ADDENDUM NO. 2

August 7, 2026

Perry Township Schools:
Southport High School Addition & Renovation Phase 2 (Classroom Addition and Athletic Renovations)
971 E. Banta Road
Indianapolis, IN 46227

Phase 2: ADDENDUM NO. 2 (TWO)

3 STAIR GUARD RAIL DETAIL AT RAMP

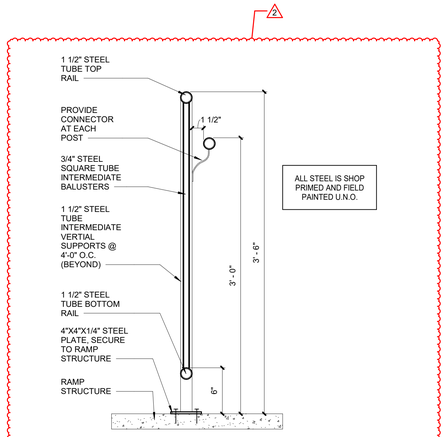
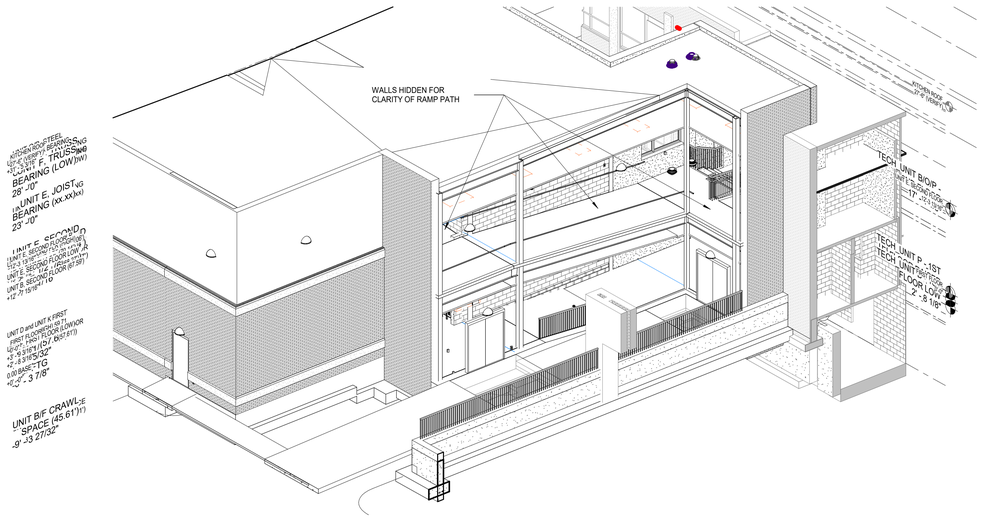
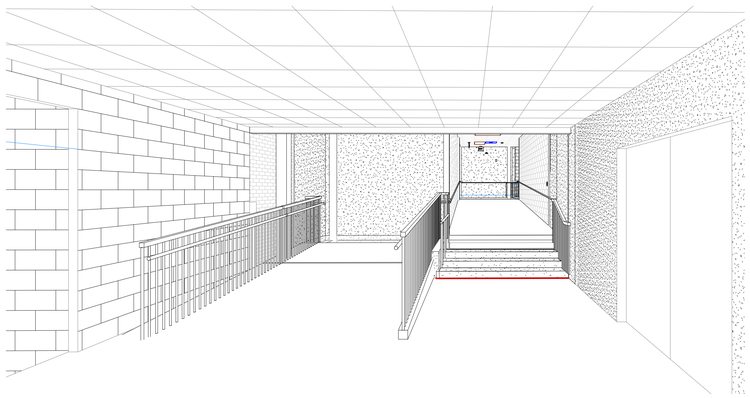
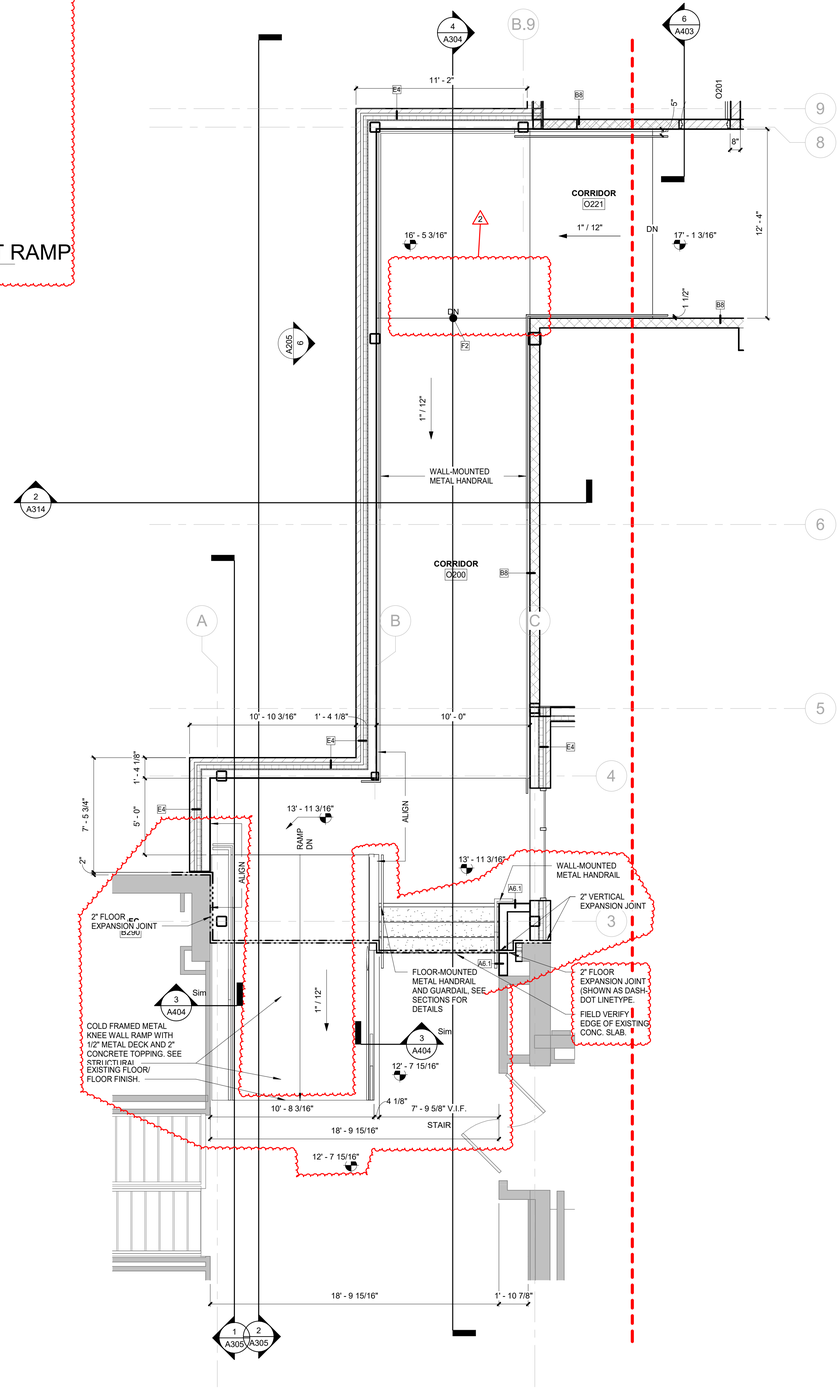
14. Drawing Sheet Number: A404
    Drawing Sheet Title: VERTICAL CIRCULATION

Change: Updated material tags
    - Add section callout 3/402
    - Clarified expansion joint notation; including deletion of notes.
    - Add section detail 3/A/402 to sheet

9 CSWK - ART ROOM P204 N

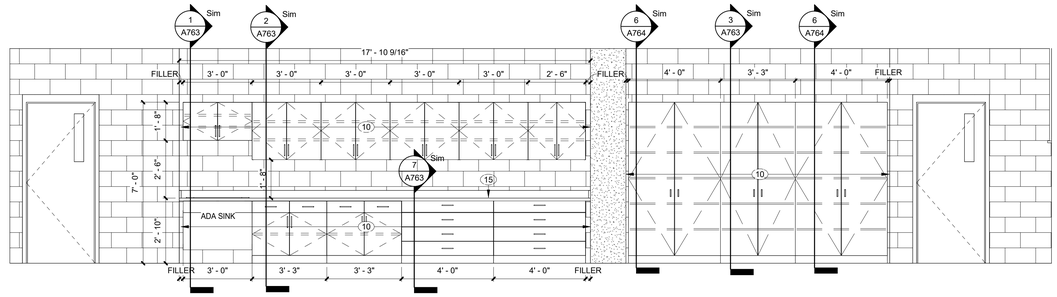
20. Drawing Sheet Number: A762
    Drawing Sheet Title: CASEWORK ELEVATIONS

Change:
    - Added casework elevation 8/A762.
    - Added casework elevation 9/A762.
    - Added keynotes 15 and 16. Applies to all interior elevation sheets.

6 CASEWORK TALL TOTE TRAY CABINET SECTION
SCALE: 1 1/2" = 1'-0" REF. 8 / A762

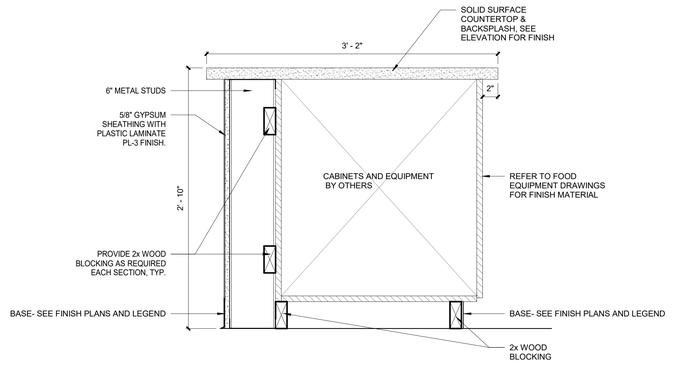
21. Drawing Sheet Number: A764
    Drawing Sheet Title: CASEWORK SECTIONS

Change:
    - Added casework section 6/A764

PLUMBING FIRST FLOOR PLAN - UNIT P

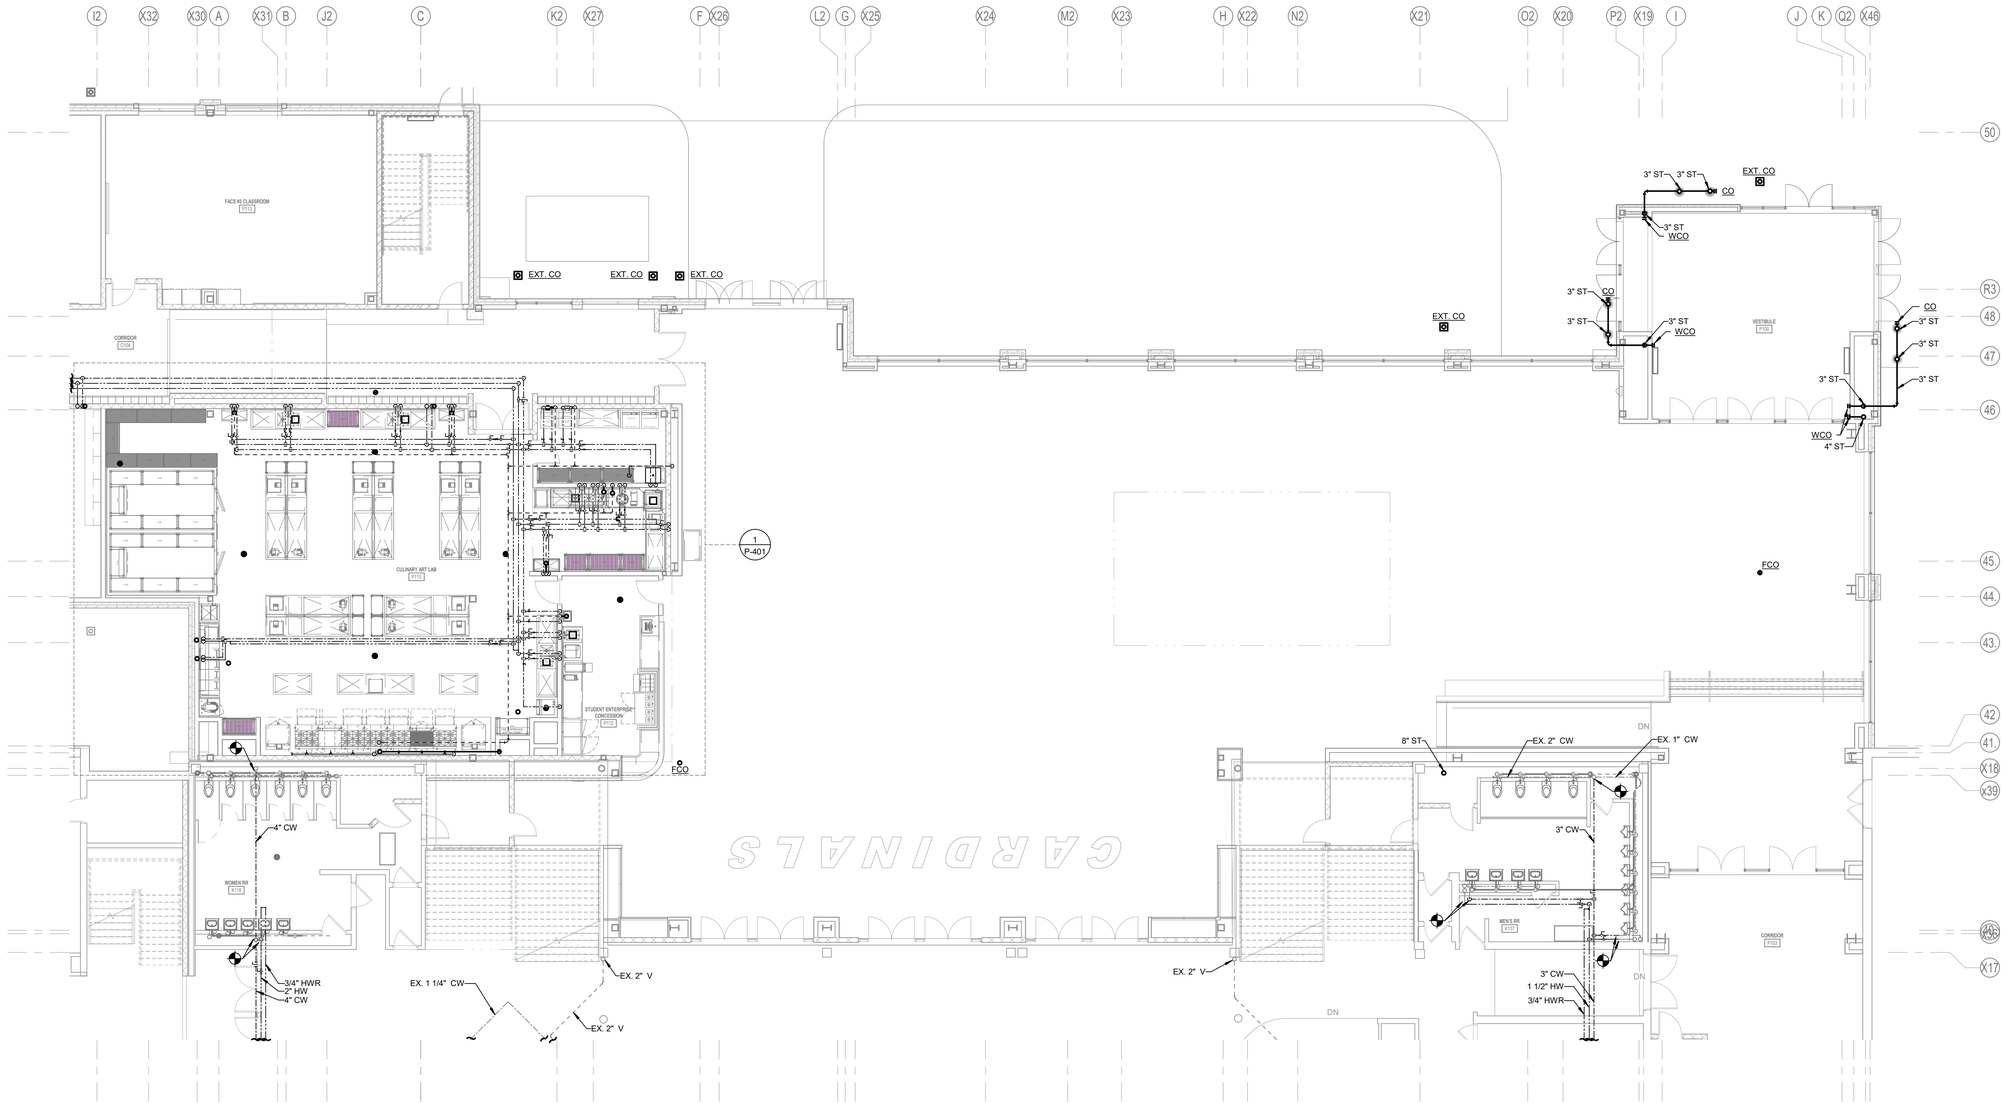
25. Drawing Sheet Number: PP105
    Drawing Sheet Title: PLUMBING FIRST FLOOR PLAN – UNIT P

Change: See revised piping.

1 PLUMBING SECOND FLOOR PLAN - UNIT P

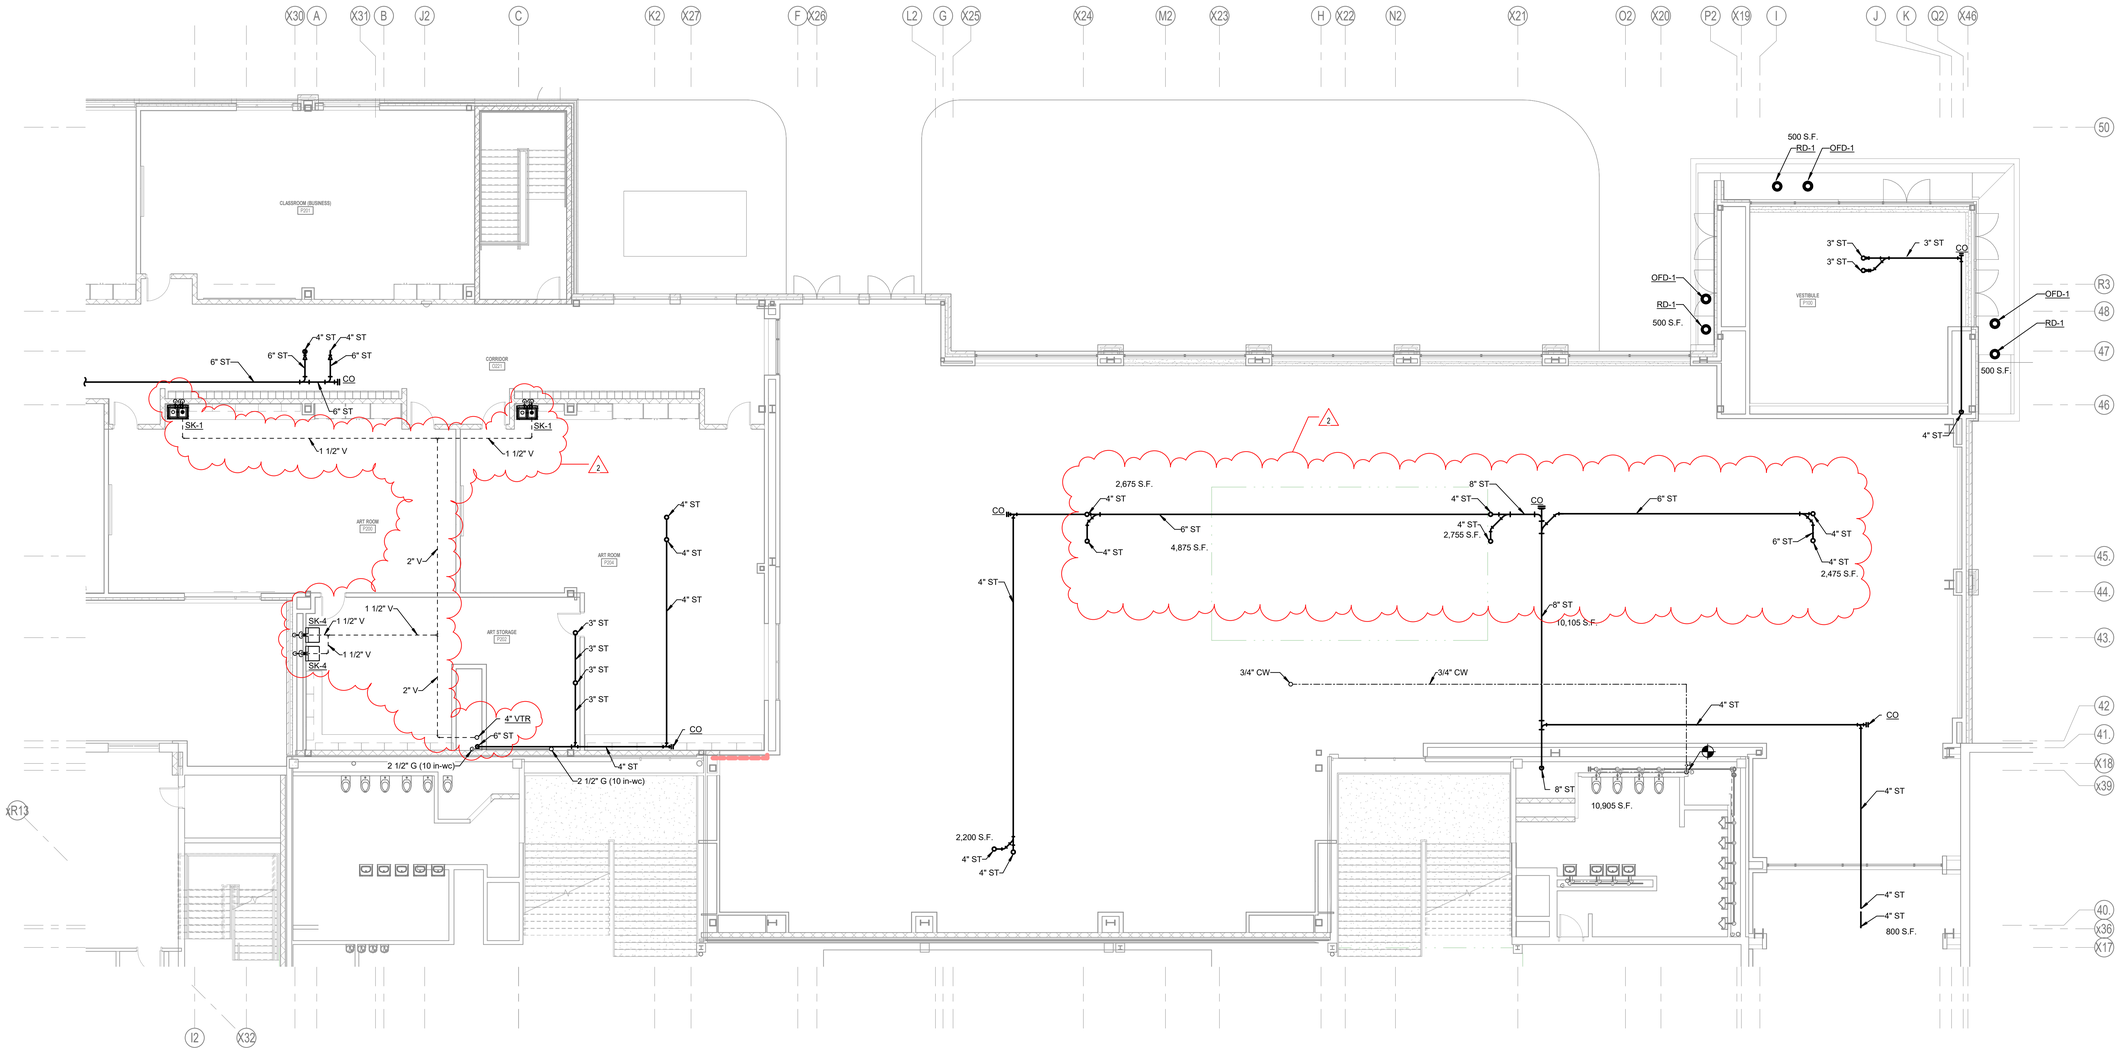
26. Drawing Sheet Number: PP107
    Drawing Sheet Title: PLUMBING SECOND FLOOR PLAN – UNIT P

Change: See new Plumbing fixtures and associated piping.

PLUMBING DOMESTIC WATER ISOMETRIC

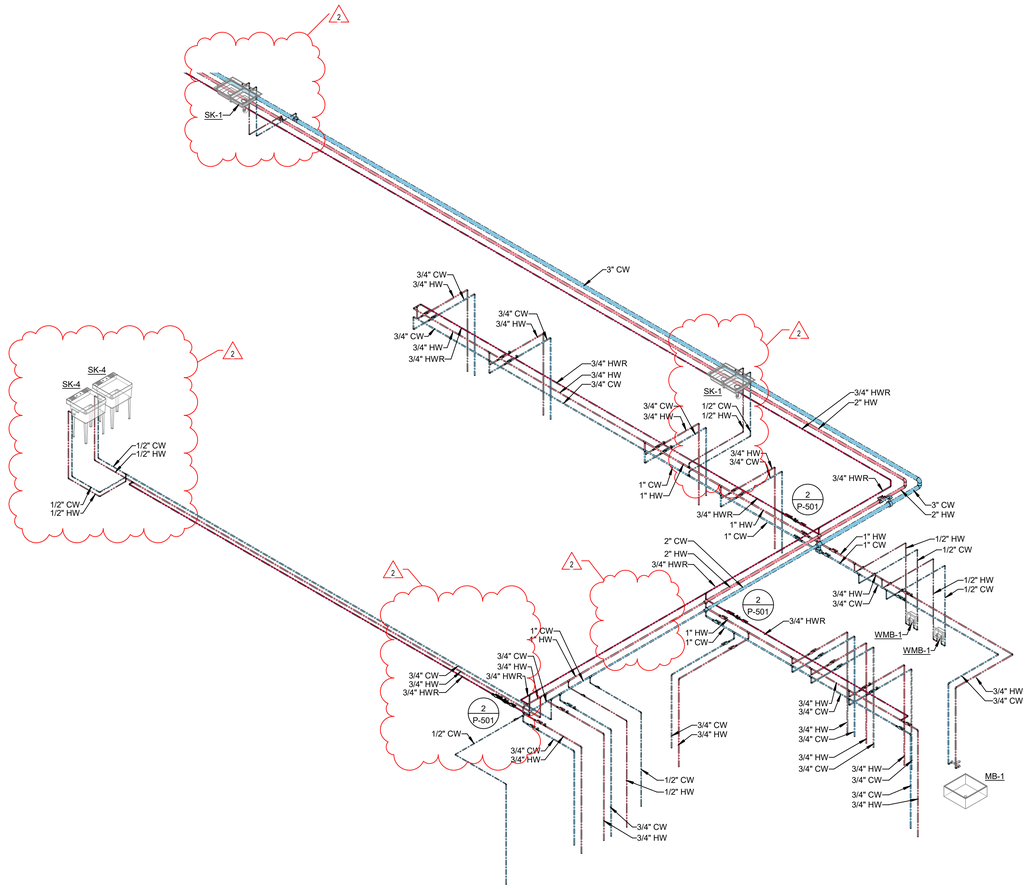
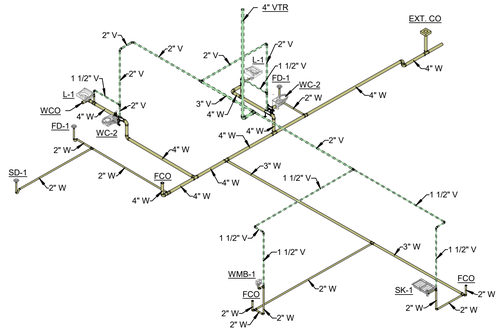
29. Drawing Sheet Number: P-901
    Drawing Sheet Title: PLUMBING DOMESTIC WATER ISOMETRIC

Change: See revised piping in Culinary Art Lab.

2 **PLUMBING WASTE AND VENT ISOMETRIC - UNIT P**
NOT TO SCALE

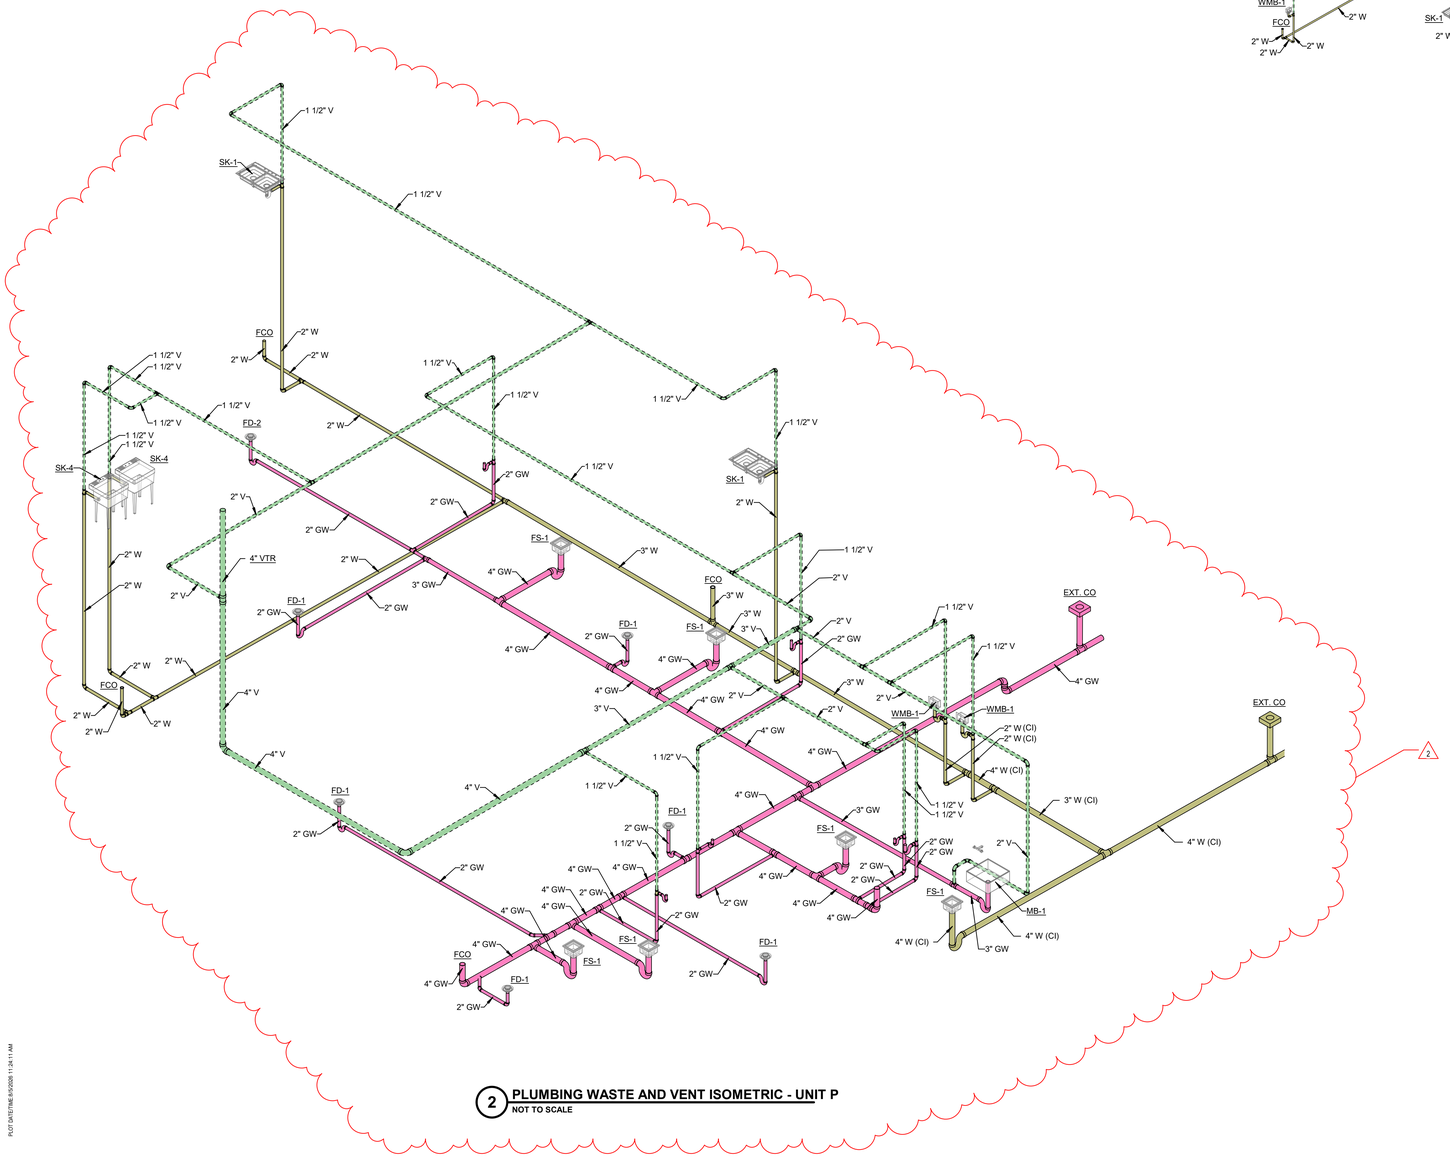
30. Drawing Sheet Number: P-902
    Drawing Sheet Title: PLUMBING WASTE AND VENT ISOMETRIC

Change: See revised piping in Unit P.
